DELAWARE DEPARTMENT OF TRANSPORTATION	ADDENDUMS / REVISIONS	NOT TO SCALE	SR1 / I-95 INTERCHANGE	CONTRACT 28-090-03	BRIDGE NO.	TYPICAL SECTIONS	SHEET NO. 10
	ADDENDUM NO. 3 CHANGED ITEM NO., 02/18/2011, RLS			COUNTY NEW CASTLE	DESIGNED BY:		TOTAL SHTS. 803
					CHECKED BY:

DELAWARE DEPARTMENT OF TRANSPORTATION	ADDENDUMS / REVISIONS ADDENDUM NO. 3 CHANGED ITEM NO., ADDED O.H. SIGN REMOVAL, 02/18/2011 RLS	SCALE 0 50 100 150 FEET	SR1 / I-95 INTERCHANGE	CONTRACT 28-090-03 COUNTY NEW CASTLE	BRIDGE NO. DESIGNED BY: CHECKED BY:	CONSTRUCTION PLAN

DELAWARE DEPARTMENT OF TRANSPORTATION	ADDENDUMS / REVISIONS: ADDENDUM NO. 3 VOIDED SHEET; MODIFIED ITMS DESIGN SEE SHEET 711A, 02/18/2011, JCR	SCALE 0 50 100 150 FEET	SR1 / I-95 INTERCHANGE	CONTRACT 28-090-03; COUNTY NEW CASTLE; BRIDGE NO.; DESIGNED BY:; CHECKED BY:	SIGNING, STRIPING & CONDUIT PLAN; SSC-1; SHEET NO. 711; TOTAL SHTS. 803

ADDENDUMS / REVISIONS	
ADDENDUM NO. 3 THIS SHEET 724A	
REPLACES VOIDED SHEET 724	
02/18/2011, JCR

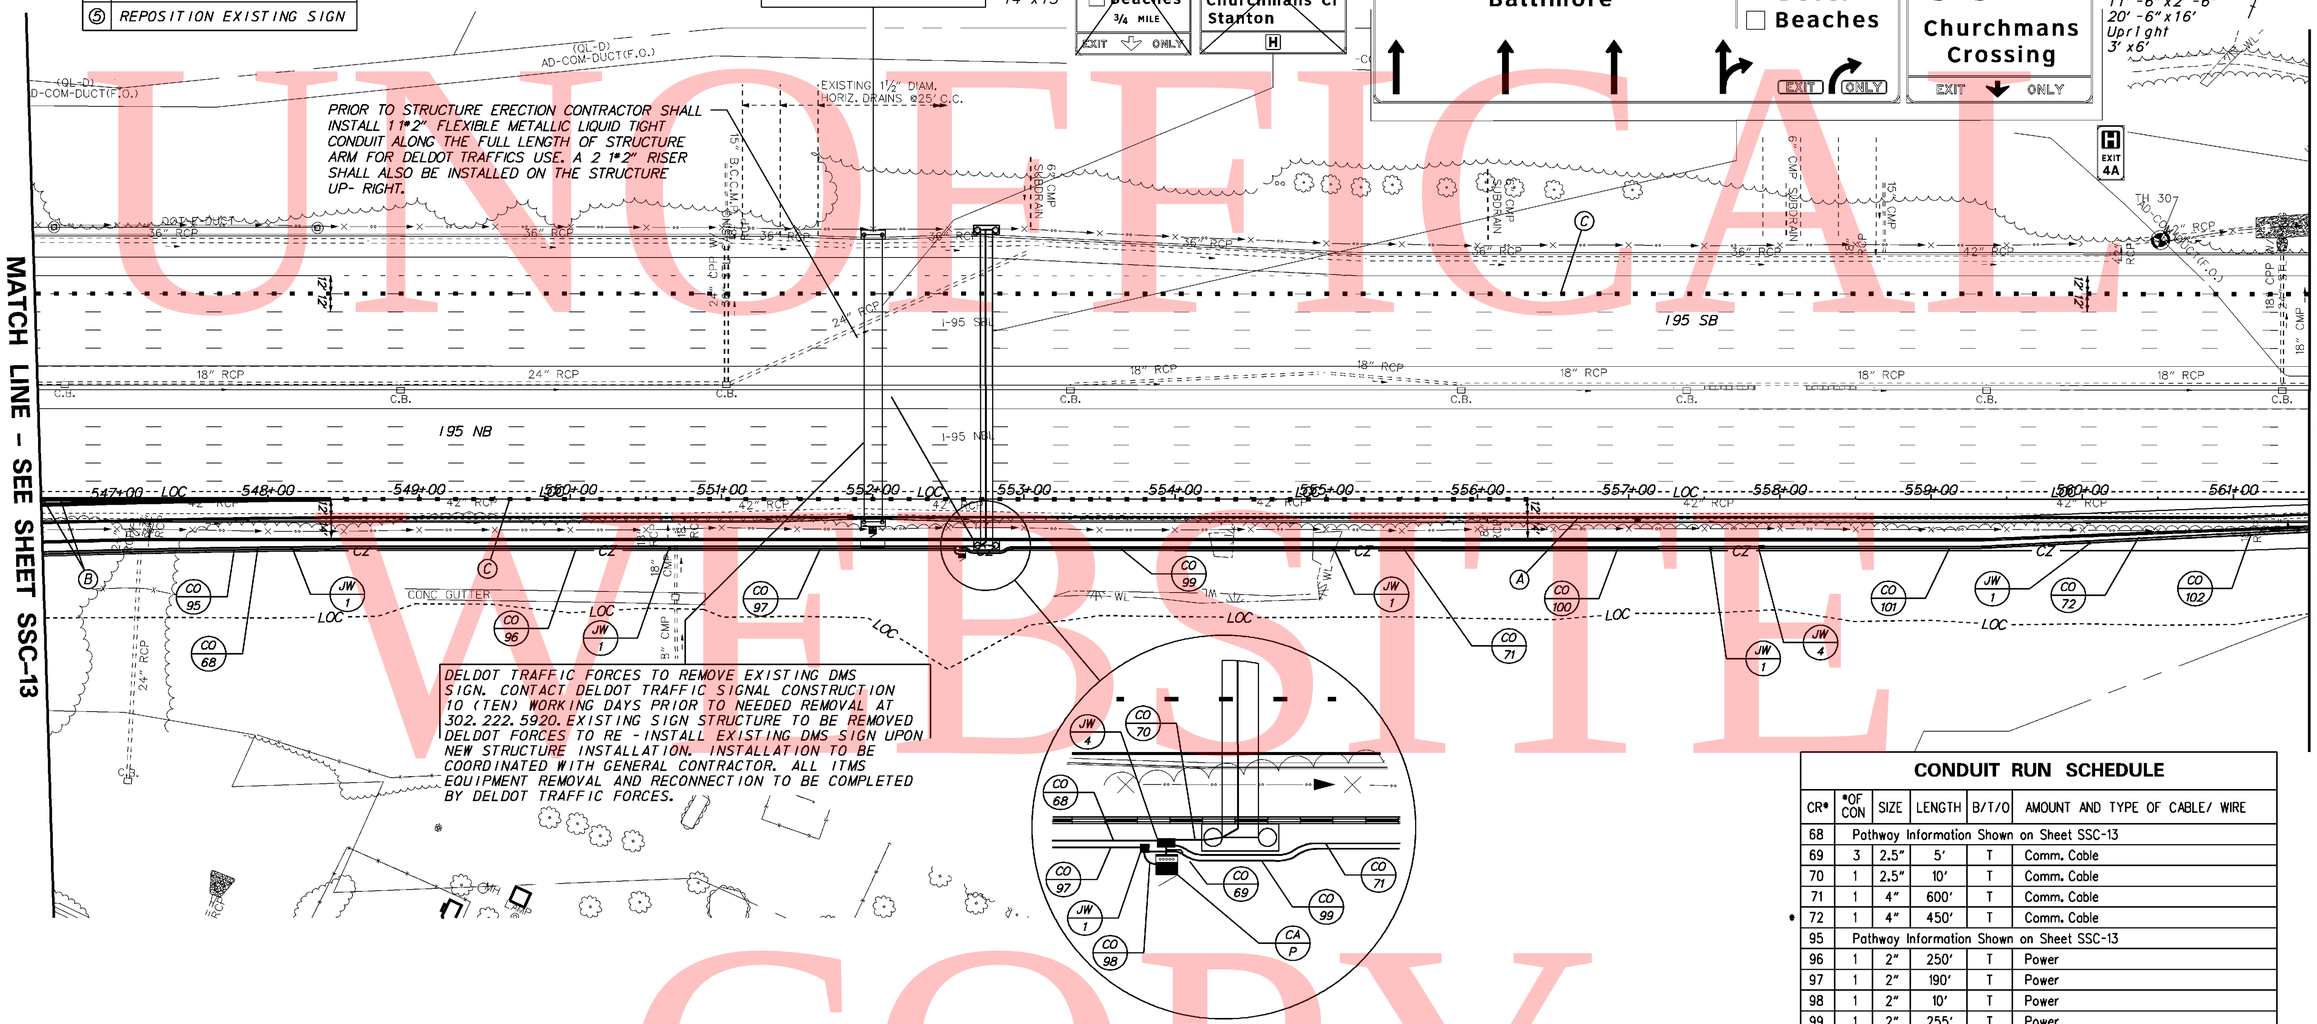
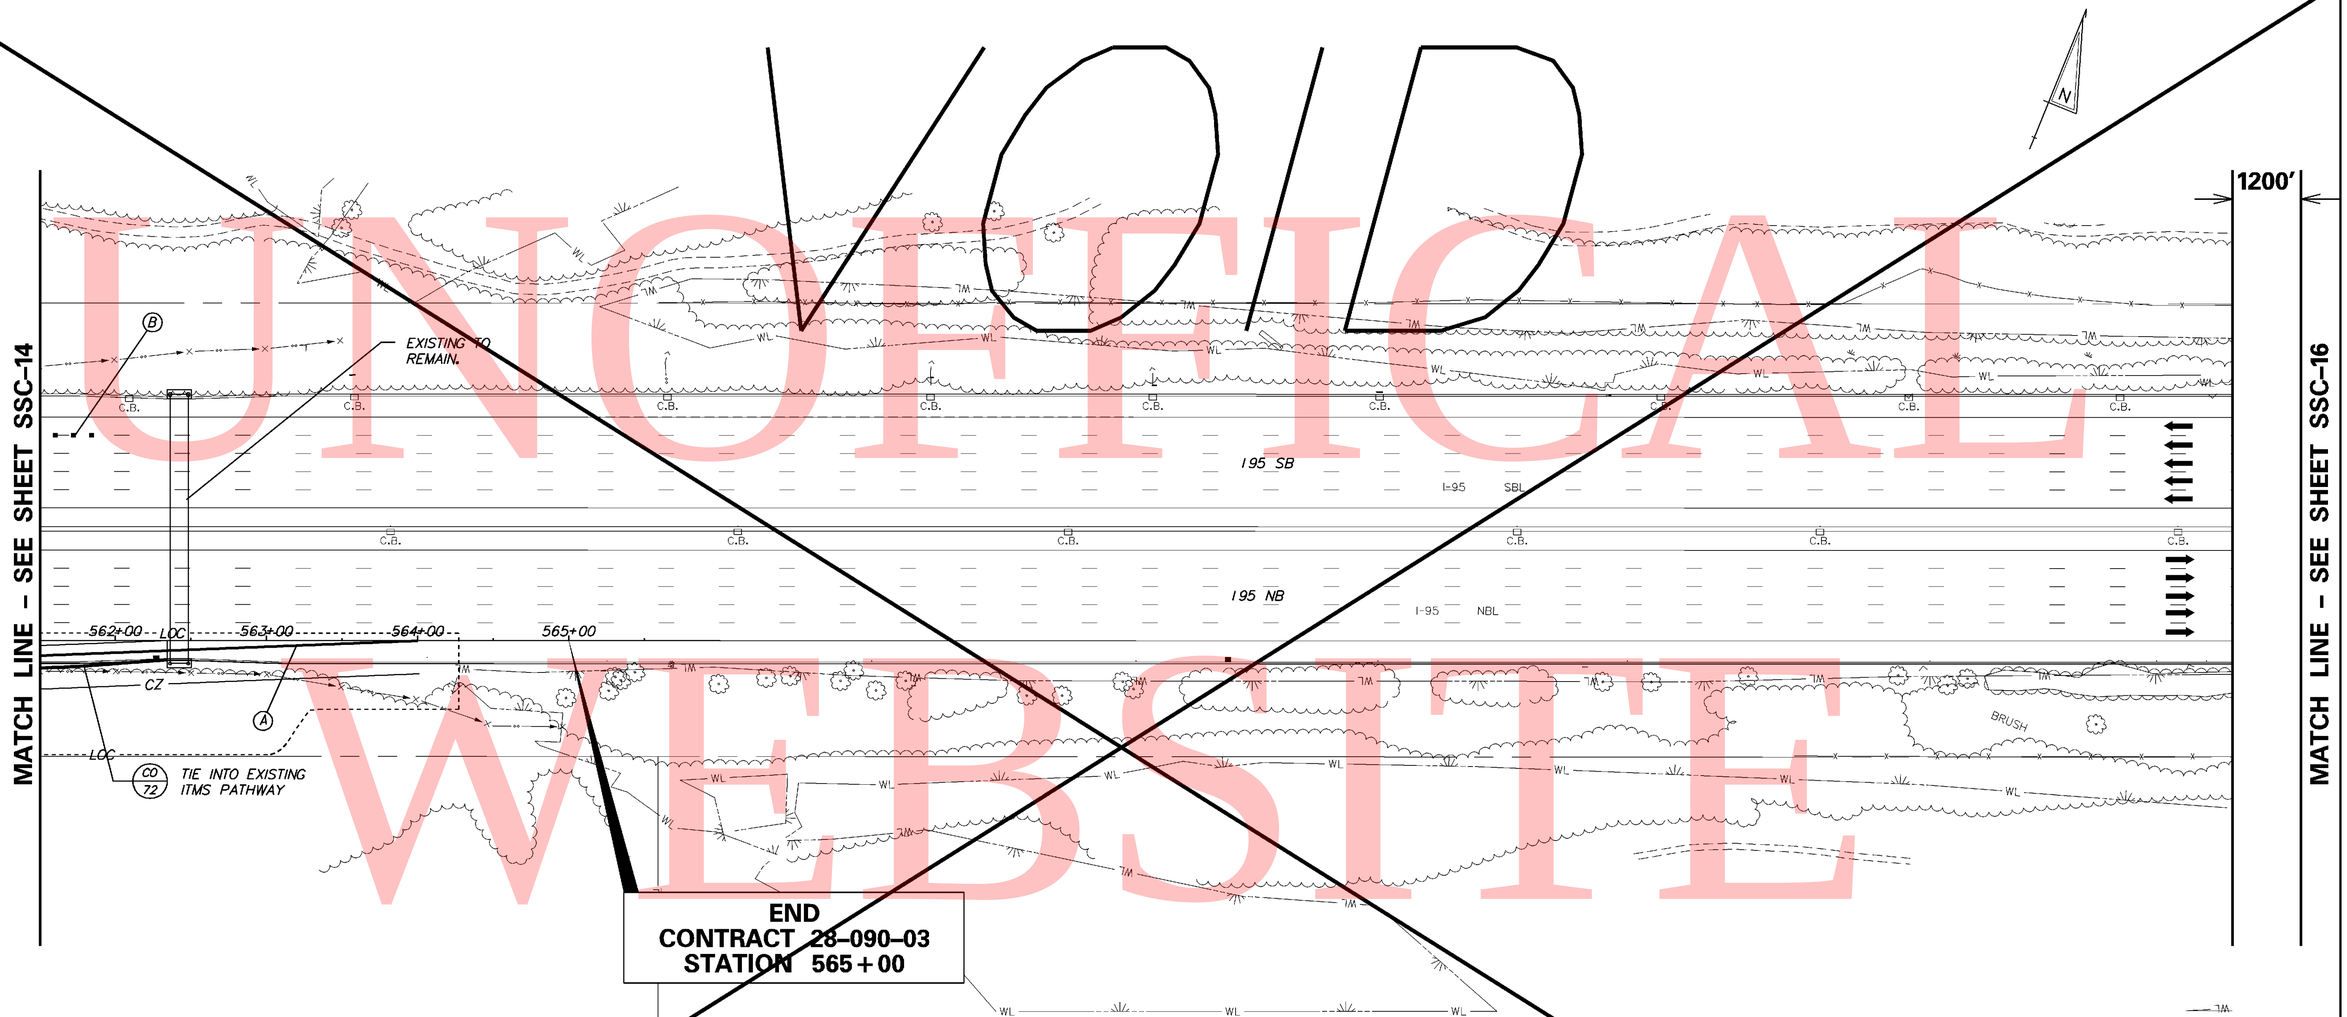
ADDENDUMS / REVISIONS	
ADDENDUM NO. 3 , VOIDED SHEET 724	
MODIFIED ITMS DESIGN SEE SHEET 724A,	
2/17/11 JCR

CR*	*OF CON	SIZE	LENGTH	B/T/O	AMOUNT AND TYPE OF CABLE/ WIRE
68	Pathway Information Shown on Sheet SSC-13				
69	3	2.5"	5'	T	Comm. Cable
70	1	2.5"	10'	T	Comm. Cable
71	1	4"	600'	T	Comm. Cable
* 72	1	4"	450'	T	Comm. Cable
95	Pathway Information Shown on Sheet SSC-13				
96	1	2"	250'	T	Power
97	1	2"	190'	T	Power
98	1	2"	10'	T	Power
99	1	2"	255'	T	Power
100	1	2"	250'	T	Power
101	1	2"	250'	T	Power
* 102	1	2"	230'	T	Power
